**CITY OF PORTLAND, ME
BOCA 1999 Plan Review Record
One and Two Family Dwelling**

Building Location: 82 Kansas Ave. CBL: 399-D-008

Building Description: Single family dwelling/attached private garage

Subject: Lot 23 Kansas (Pines)
82 Kansas Ave. Revised Plans.

Lot 23
KANSAS
82 Kans. Ave.

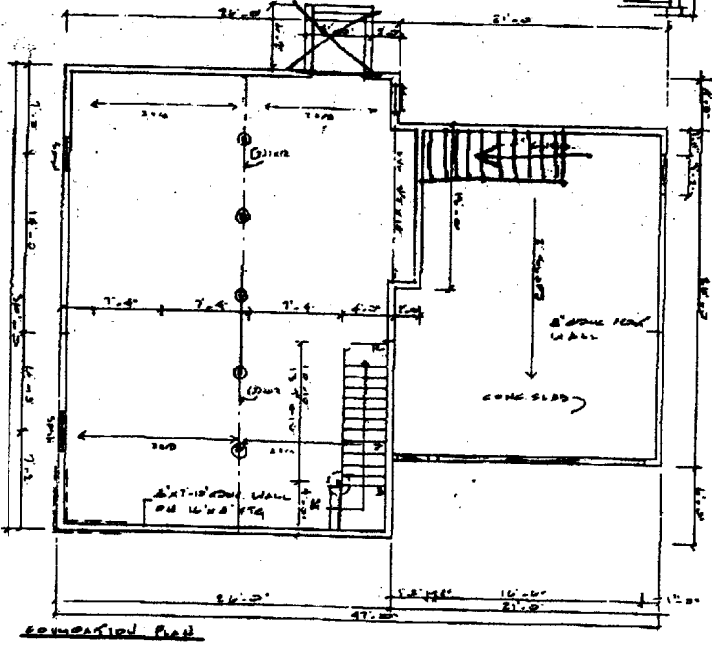
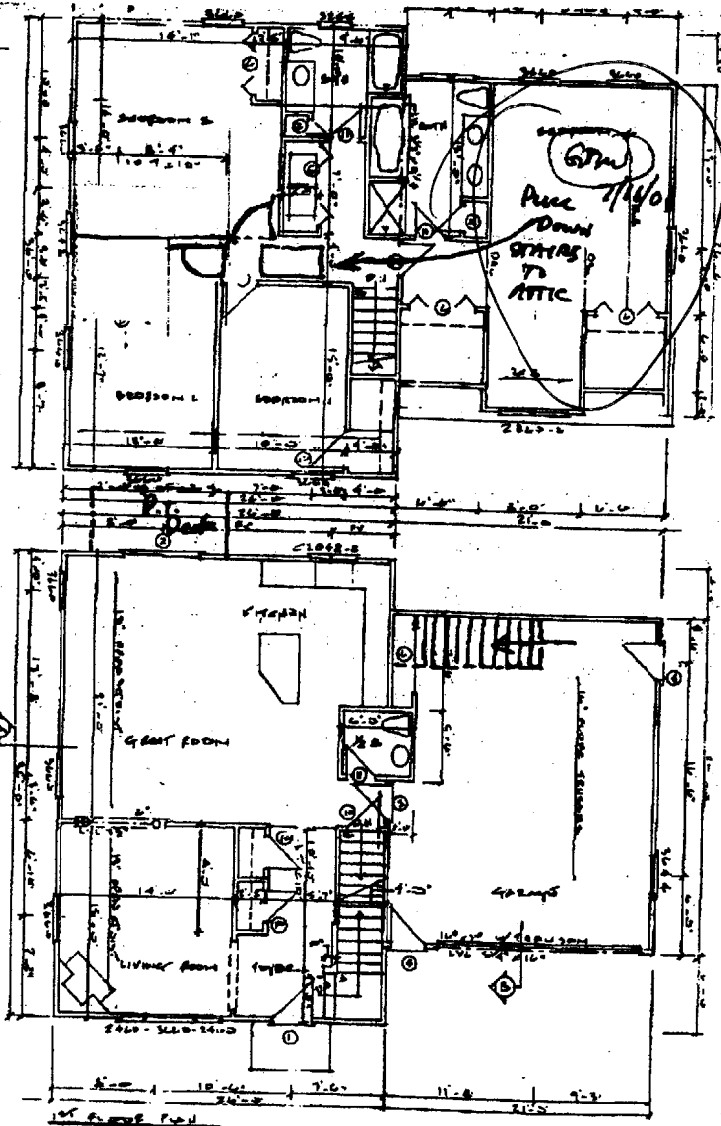
Dear Marge; We have changed plans to reflect the fact that the attic will be unfinished; we eliminated stairs to attic and eliminated the window originally shown on the submitted application.

Removed Stairs to
3rd Floor

Revised
Plans
7/11/01
GTM
